March 3, 2020

**RE: Sightline Review – Road A, Windgate Drive Access
 Beaver Bank, Nova Scotia**

Figure 2 – Sightline Review

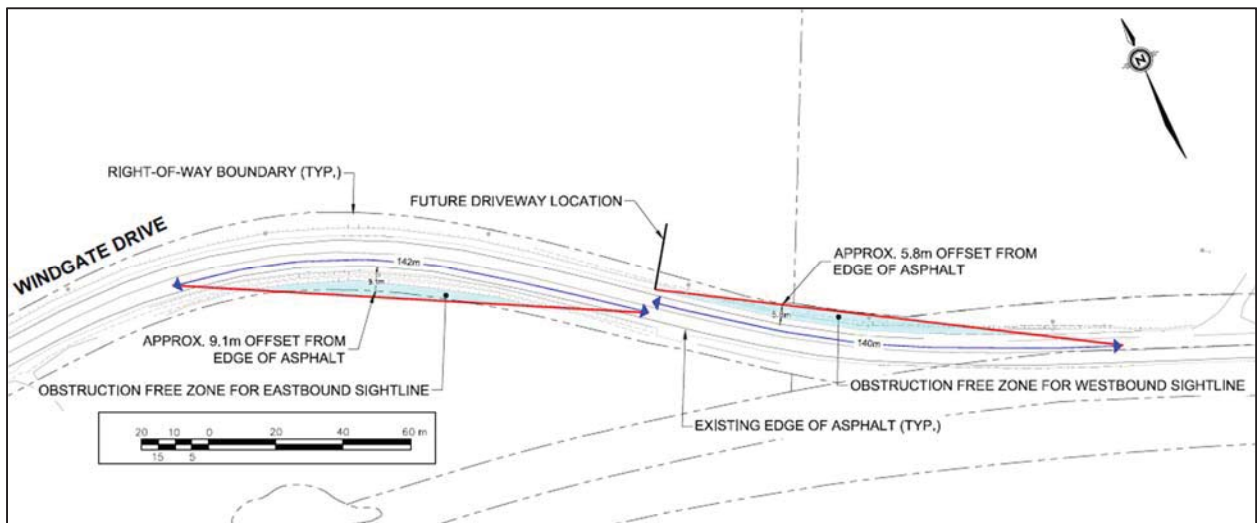
- The eastbound approach will require 140 m of unobstructed sightlines in order for a vehicle to make a controlled stop travelling 80 km/h on a -1% (downhill) grade; and,
- The westbound approach will require 142 m of unobstructed sightlines in order for a vehicle to make a controlled stop travelling 80 km/h on a -2% (downhill) grade.

Upon review of the recently acquired topographic survey data, it was determined that adequate stopping sight distances will be available for the eastbound and westbound approaches along Windgate Drive with some tree clearing and regular maintenance (See Figure 2). The obstruction-free zone for the eastbound sightline is expected to be 9.1 m offset from the edge of asphalt near the midpoint, as shown in Figure 2. It should be noted that the outlined obstruction-free zone encroaches beyond the existing right-of-way. The obstruction-free zone for the westbound sightline is expected to be 5.8 m offset from the edge of asphalt near the midpoint, as shown in Figure 2. The driver eye and object heights were plotted and compared to the elevation profile from the topographic survey data. Based on the surface review, it was determined that the existing roadway profile will not impede driver sightlines. In addition, sightline clearance beyond removal of vegetation is not expected to be required.

In conclusion, adequate stopping sight distance is expected to be available on Windgate Drive towards Road A with the recommended tree clearing west and east of the propose site access road.
